**Job Title:** Sunnica Energy Farm DCO Scheme, Cambridge  
**Job No:** 2022-4937  
**File Ref:** CA4937-N01-DR-SM-Transport Note (221111)(220268477.1).docx  
**Date:** 11/11/2022

**Subject:** **Sunnica Energy Farm – DCO Scheme**  
**Assessment of Transport Impacts at Federated Hermes Property Unit Trust Campus,**  
**Newmarket Road, Fordham, Cambridgeshire**

**Figure 1: WSP SEF PCE Plan (PCEP) HPUT Extract (Marked Up)**

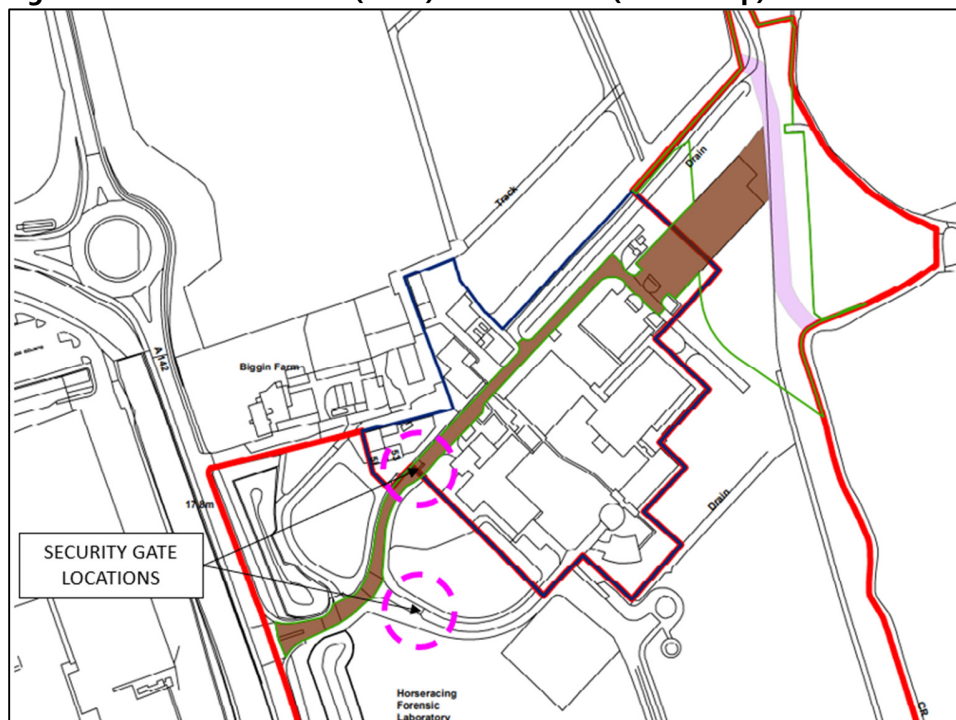
14. Security gates are located at the Campus as highlighted in Figure 1 above. These are the only entry and exit points into the facility.
15. The brown hatched area shown on the PCEP also includes a staff car park (comprising some 136 car parking spaces) to the rear of the Campus.

(including deliveries) are therefore by prior arrangement only and access to the Campus via the security gates referred to above (highlighted in Figure 1 above) is strictly controlled / monitored.

**Figure 3: Sunnica West Site A and Site B Site Accesses Extract (Marked Up)**

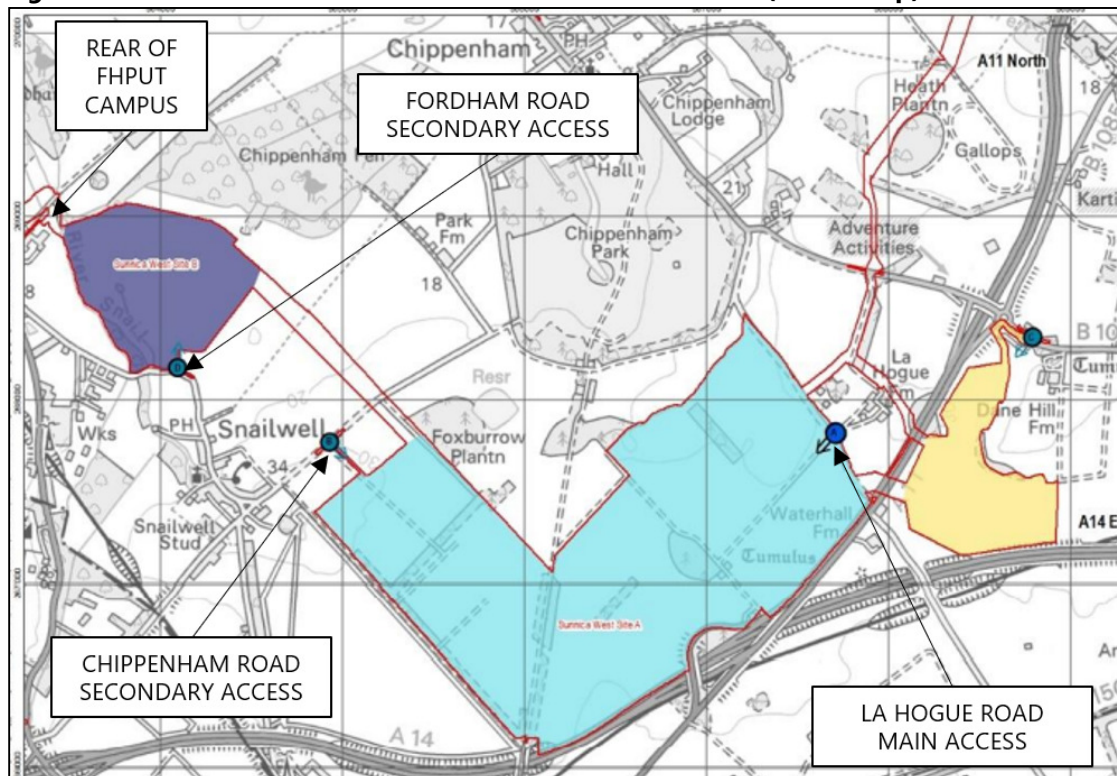
33. Paragraph 5.4.9 of the TA states that the main access to the Sunnica West Site A and Site B is proposed to be from La Hogue Road and that to minimise the number of HGV movements on the local road network, internal routes from the main access will be used. It also states that where HGVs are unable to use internal routes, the secondary access points (described above and highlighted in Figure 8 above) will be used.

34. However, paragraph 3.2.4 and Table 3.2 of the TA indicates that Fordham Road and Chippenham Road (the roads where the secondary access points are proposed) are not recommended routes for HGVs (as defined by Cambridgeshire County Council's (CCC's)) and therefore, given the DCO Scheme includes Access Rights and Cable Rights over the Campus, that could result in an unconstrained number of HGVs and other vehicle movements along the Campus access road and within the rear car park, it is considered that there is the potential for the need to access Sunnica West Site A and Site B via the Campus.

35. The DCO Scheme does not consider the potential for the Sunnica West Site A and Site B to be accessed via the Campus. For the reasons set out in this note, the routing of construction vehicles associated with Sunnica West Site A and Site B along the Campus access road and rear car park is unacceptable.

**Figure 4: Access and Rights of Way Plans (Sheet 16) Extract**

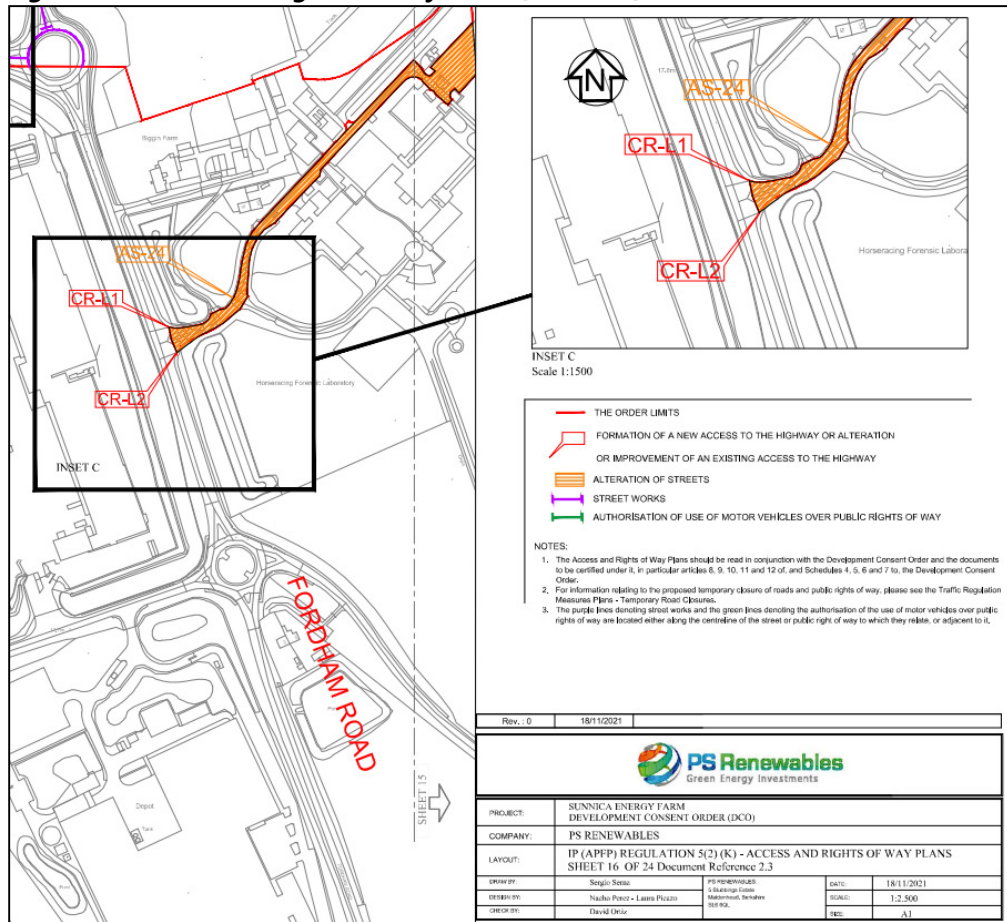
36. Paragraph 5.4.21 of the TA states that the access locations associated with the construction of the cable are shown on the Access and Right of Way Plans (ARWP). Sheet 16 of the ARWP includes the proposed access route through the Campus. An extract from Sheet 16 of the ARWP is included in **Figure 4** below.

37. Paragraph 5.4.20 of the TA states that on average there will be up to 23 HGV deliveries (46 vehicle movements) per day associated with the cable installation works. However, data included in Annex E of the TA (see table referenced 'Burwell Substation to Sunnica West A') indicates that during peak times there will be 23 HGV deliveries and 3 LGV deliveries per day, on average, during the cable installation works.

39. Table 6.2 of the TA indicates that the works to Sunnica West Site A and Site B and the cable installation works could take place in parallel. Therefore, if there are issues with internal routes, and the secondary access points off Fordham Road and Chippenham Road are found to be unsuitable for HGVs, permission to use the access off the A142 via the Campus for construction

**Figure 5: Land and Crown Land Plans (Sheet 16) Extract**

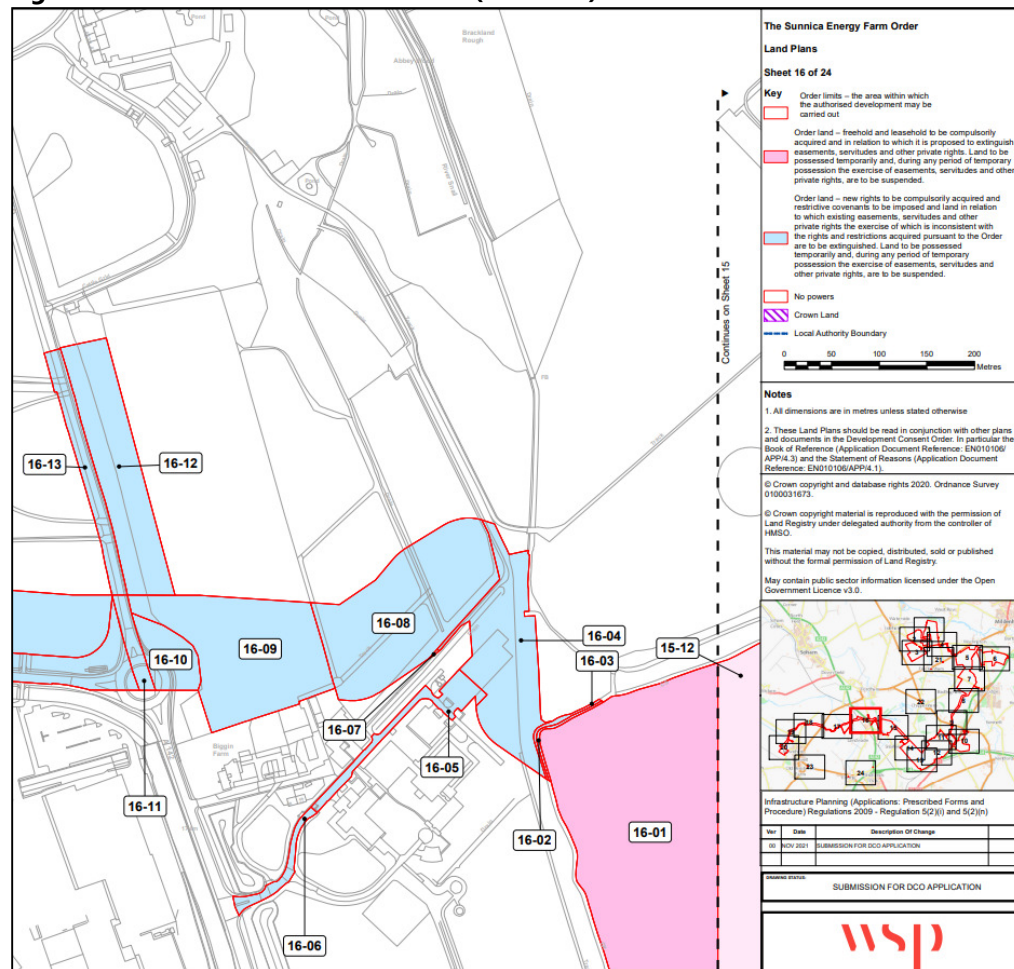
46. In addition, to all the permanent rights being acquired, the DCO Scheme would allow Sunnica Energy Farm to enter on and take temporary possession anywhere within the Order Limits (see land bounded in red on the LCLP / Figure 5 above) and enable the construction of the authorised development in order to remove anything on the land, construct temporary works, structures and buildings etc in connection with the authorised development.

**Figure 6: ES Pre-Application Scoping Cable Route Options Extract (Marked Up)**

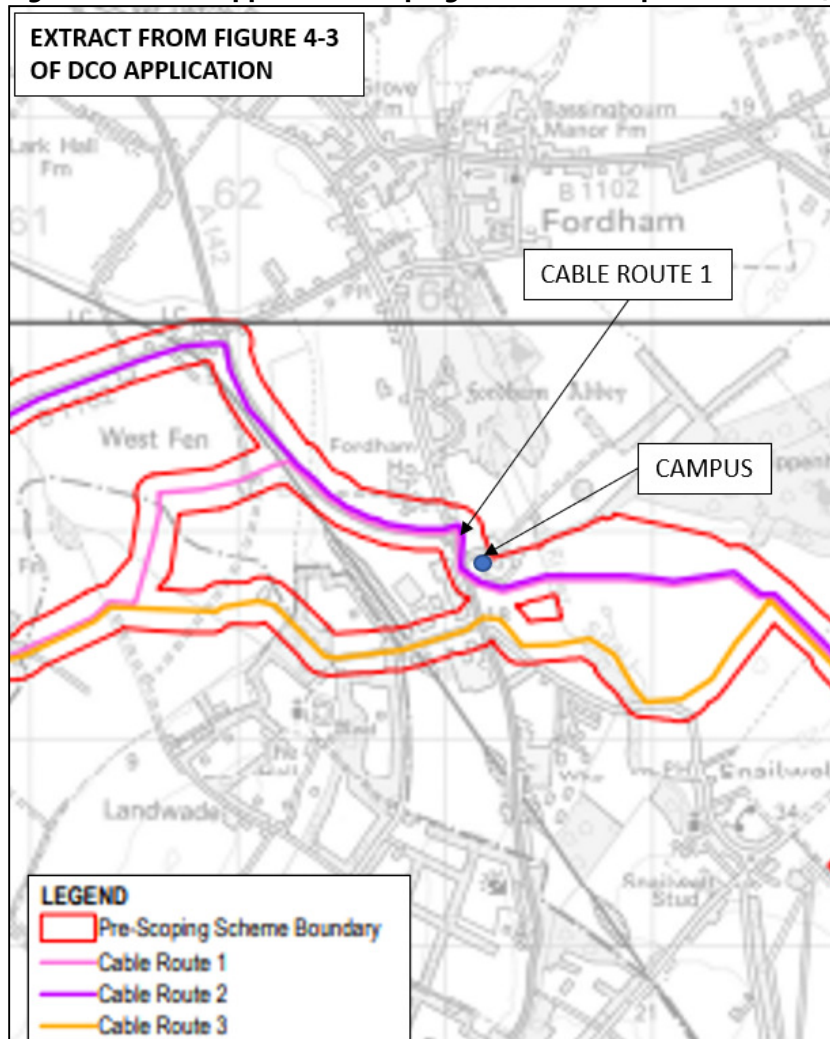
63. Option 1 was selected as the preferred option. As is apparent from the figure above, Option 1 (shown in light pink) ran to the west and south of the Campus.
64. Paragraph 4.8.7 of the ES states that the cable route alignment was amended in response to the EIA Scoping process to avoid the sewage treatment works to the north of Burwell. Paragraphs 4.8.8 and 4.8.9 provide additional reasons for amending the cable route alignment. However, these mainly relate to the railway crossing which is to the west of the Campus.
65. Rather than pursuing Option 1, the DCO Scheme proposes an alternative cable route, which runs to the north of the Campus and requires access through the Campus. The DCO Scheme fails to

explain in detail why the preferred cable route alignment was amended to route to the north of the Campus as currently proposed.

**Figure 7: Potential Alternative Cable Route Alignment (Shown Indicatively)**

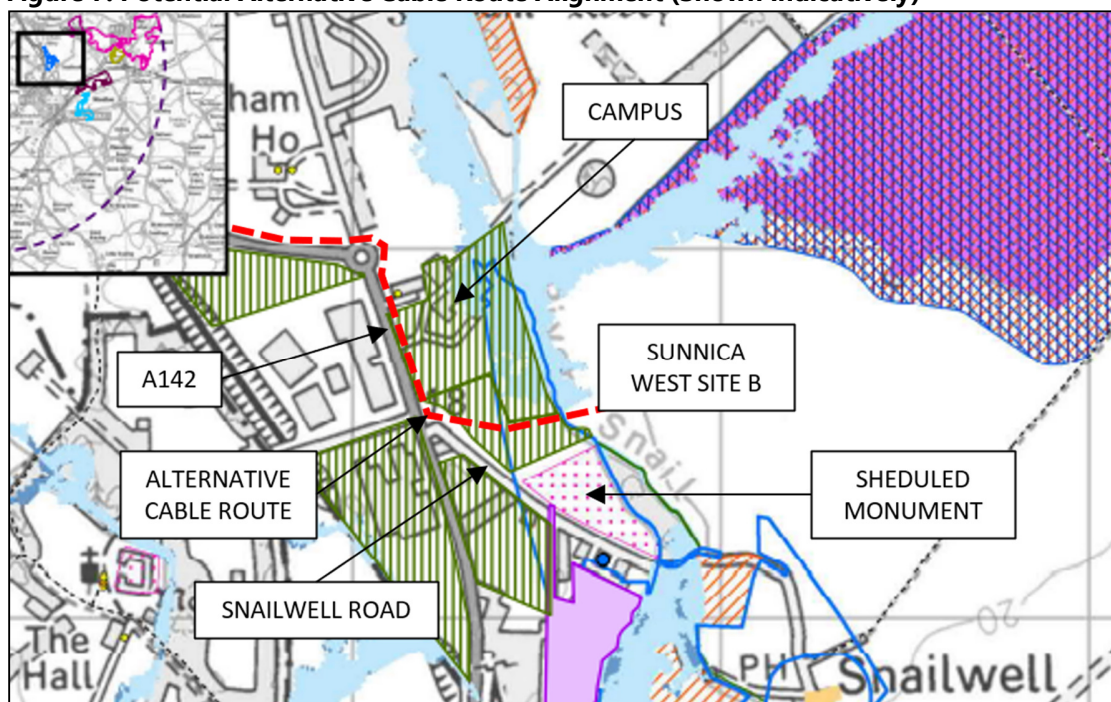
66. For reasons which are not apparent, the DCO Scheme fails to consider or assess in detail an option where the cable route runs parallel to the A142, Newmark Road, (on the east or west side of the road) between the roundabout junction of the A142, Newmarket Road, and Newmarket Road (located to the north west of the Campus) and the junction of the A142, Newmarket Road, and Snailwell Road before turning east towards the River Snail and Sunnica West Site B between the 'Scheduled Monument' and the Campus.
67. The above alternative cable route is shown indicatively on a marked-up version of Figure 9E 'PDA5: Land at Snailwell Constraints' (of Annex D (Assessment Mapping), ES Appendix 4A (Alternative Sites Assessment)) in **Figure 7** below.

68. If the cable was to route as shown in Figure 7 above and access was achievable from Sunnica West Site B and / or from Snailwell Road the access route via the Campus would no longer be required. This would remove the potential for the DCO Scheme to disrupt the operations that take place at the Campus.

**Figure 8: WSP's 'Property Cost Estimation Plan Sheet 1 of 1' Extract (Mark-Up)**

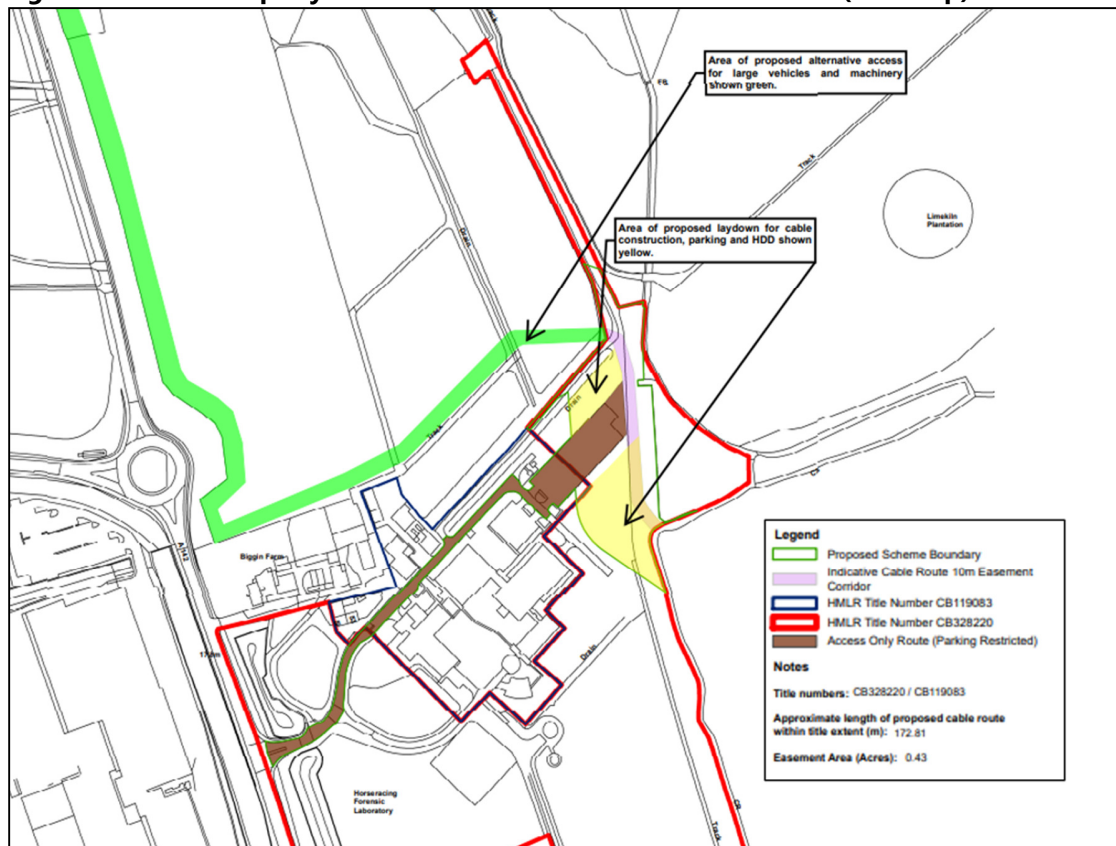
74. The Campus is not suited to conveying third party construction traffic of any scale and it is not clear why all such traffic (cars, light vans and HGVs) cannot be routed via the access route to the north of the Campus shown green on the Figure above and the revised PCEP. Even so, we are instructed by FHPUT to continue to engage with Sunnica Energy Farm in an attempt to explore whether these proposals are sufficient to overcome its objection.

75. Given the DCO application and the Outline CTMP and Travel Plan includes caveats that would enable Sunnica Energy Farm to re-evaluate the access arrangements if the DCO Scheme is approved and that Sunnica Energy Farm are not proposing to remove the access route via the Campus entirely, there remains the potential for HGVs and cars / light vans to route via the Campus and for the car park to the rear to be closed to staff which would result in significant disruption to the operations that occur at the Campus.

73. With reference to the above Figure, Sunnica Energy Farm's revised proposals, whilst not yet secured in any way, appear to be as follows:
- Areas for construction laydown and parking for Sunnica vehicles are coloured yellow (within an area currently the subject of proposed Access Rights) to the north and south of the Campus car park hatched brown (an area currently the subject of proposed Access Rights).
  - All HGVs and large machinery are to be routed via the Cable Route Access Location K referred to above and the area of land located to the north of the Campus (shown via the green line on the above Figure) instead of routing HGVs and large machinery through the Campus.
  - Only cars / light vans would use the proposed access route through the Campus to access the laydown and parking areas coloured yellow.

- Sunnica Energy Farm has indicated that a maximum of 15 cars / light vans (up to a maximum gross weight of 3.5 tonnes) would route through the Campus.

- Sunnica Energy Farm has indicated that the revised arrangements would not require the use of any existing Campus car parking bays, all of which would remain available for use by the Campus throughout all construction, operation, and decommissioning of the DCO Scheme.

- Sunnica Energy Farm has indicated that HGVs and large machinery would access the proposed cable installation works laydown and parking areas via the cable route corridor coloured purple on the revised PCEP, avoiding the need for HGVs and large machinery to be routed via the access through the Campus and the Campus car park to the rear.

- Sunnica Energy Farm has indicated that there is to be no parking of vehicles associated with the DCO Scheme on the access route through the Campus or rear car park hatched brown on the revised PCEP.
